LYDD AIRPORT RUNWAY EXTENSION PLANNING APPLICATION:

REVIEW OF ASPECTS OF LYDD AIRPORT RESPONSE TO SHEPWAY COUNCIL DECEMBER 2009

Report No. 10/246/LAAG/1

Noise Footprint Comparison

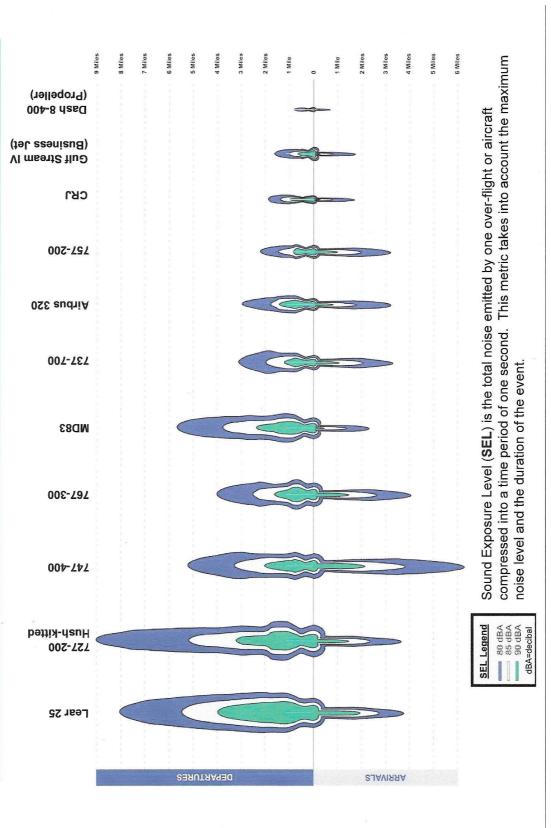
sustainable when the respective noise profiles of the two aircraft types are compared. Appendix 1 is an excerpt from a document published by Seattle-Tacoma Airport in the USA. It provides a graphic illustration of the difference in noise footprint between a Boeing 737-700 (centre-right of the diagram) and a Dash 8-400 (far right). The Dash 8-400 is similar to the ATR42 in that it is a twin-turboprop airliner. However it is larger than the ATR42 and its US Federal Aviation Agency certified noise levels are higher in all phases of flight than those of the ATR42. It can be seen from this that the noise footprint of a twin-turboprop aircraft such as the ATR42 is a fraction of the size of that of a Boeing 737 and that, concomitantly, the level of noise generated by a Boeing 737 is significantly greater at a given distance from the flight path than that of the ATR42.

4.2 Noise levels from future Boeing 737 movements will be significantly higher than those from any existing ATR42 movements. Visual disturbance is also likely to be greater due to the significant difference in size between the two types.
